ADDENDUM NO. 2
Bid Due Date: 7/20/23

Description: Richmond Library Roof Systems Replacement

Richmond Library Roof RFP (Re-Bid)

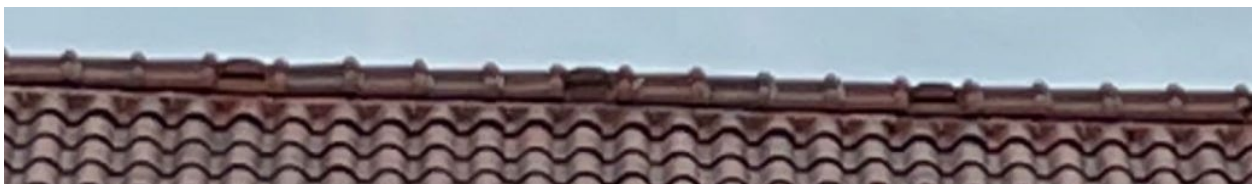
3. The current Ludowici roof has a vented ridge (type II) roughly every 5 ft on center. Are we to match this vented tile in kind and installation? It is called out in the specification but just confirming.

A: Confirmed as indicated in specification.
